Access Compliance Report

Public Rights-of-Way

(Curb Ramps)

Intersection ID: 12446	Main Street: ASHLAND_AV	Cross Street: BELVEDERE_AV	Location: NE
ADA ID: 2D97FCAA5E81	Ramp Type: BlendTrans1	Initial Pass/Fail: Fail	Overall Compliance: No
Codes/Mitigation Info/Possible Solution		Field Measurements/Component Compliance	
Severity Score: 1.25

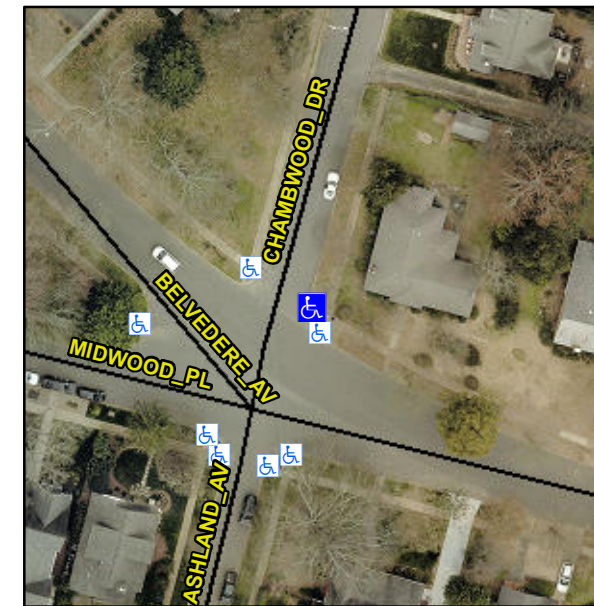
R304.5.3

Compliance	Description	Data	Compliance	Description	Data
N/A	Ramp Length (in)	88.0	Yes	BlendTrans Slope (%)	1.6
Yes	Ramp Width (in)	55.0	No	BlendTrans XSlope (%)	3.3
N/A	Flare Type LT	N/A	N/A	Flare Type RT	N/A
N/A	Flare Slope LT (%)	N/A	N/A	Flare Slope RT (%)	N/A
N/A	Flare Traversable LT?	N/A	N/A	Flare Traversable RT?	N/A
N/A	Landing Length (in)	N/A	N/A	DWS Provided?	N/A
N/A	Landing Width (in)	N/A	N/A	DWS Contrast?	N/A
N/A	Landing Slope (%)	N/A	N/A	DWS Length (in)	N/A
N/A	Landing X Slope (%)	N/A	N/A	DWS Full Width?	N/A
N/A	Landing Curb? (Y/N)	N/A	N/A	DWS Offset (in)	N/A
N/A	Shared Landing?	N/A			
N/A	Gutter Ponding?	N/A	N/A	Gutter Slope (%)	N/A
N/A	Gutter Lip Ht (in)	3.0	N/A	Gutter X Slope (%)	N/A
N/A	Painted X Walk1?	No	N/A	Painted X Walk2?	N/A
	X Walk 1 Direction	To NW		X Walk 2 Direction	N/A
	X Walk 1 Width (in)	N/A		X Walk 2 Width (in)	N/A
	X Walk 1 Slope (%)	4.1		X Walk 2 Slope (%)	N/A
	X Walk 1 X Slope (%)	1.2		X Walk 2 X Slope (%)	N/A

Remove & Replace Curb Ramp With Two New Directional Ramps or Equivalent.
